PCS Receive and Transmit State Machines

IEEE 802.3ch Interim

149.3.2.2 PCS Transmit function

Figure 149-1000—PCS 64B/65B Transmit state diagram, part a

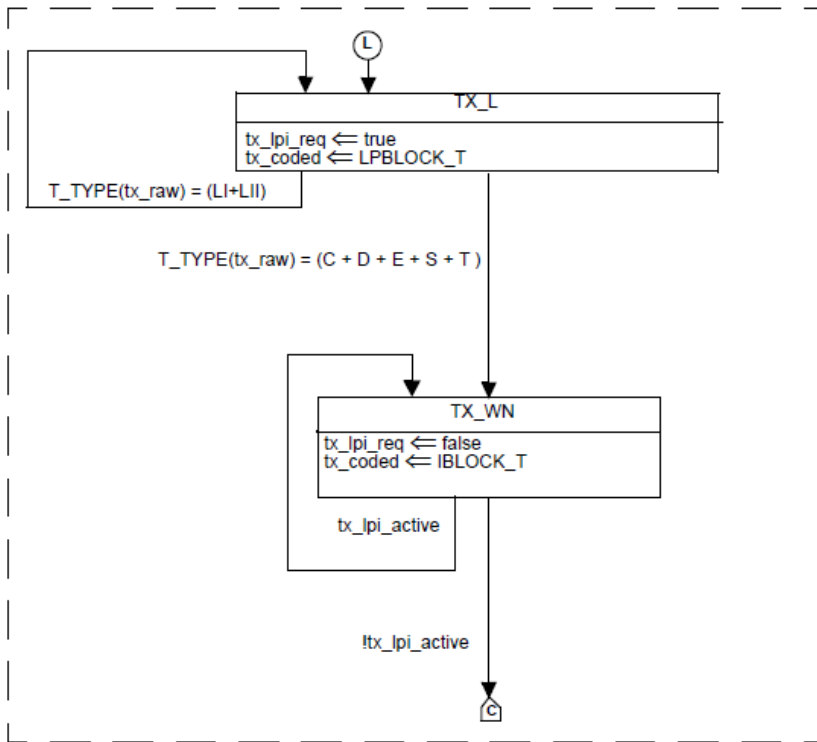
The PCS Transmit function shall conform to the PCS 64B/65B Transmit state diagram in Figure ~~136-15149-1000~~ and Figure ~~136-16149-1001~~, and to the PCS Transmit bit ordering in Figure 149-4 and Figure ~~136-8149-5~~.

NOTE—Transitions inside dashed boxes are only required for the EEE capability.

Figure 149-1000—PCS 64B/65B Transmit state diagram, part b

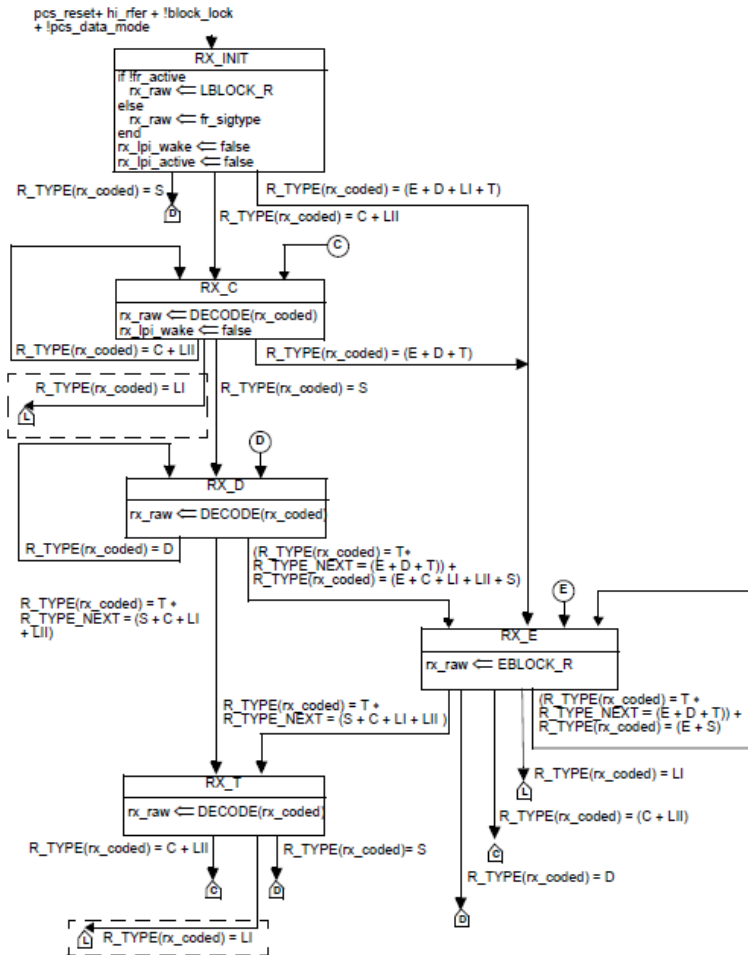
NOTE—This figure is mandatory for PHYs with the EEE capability.
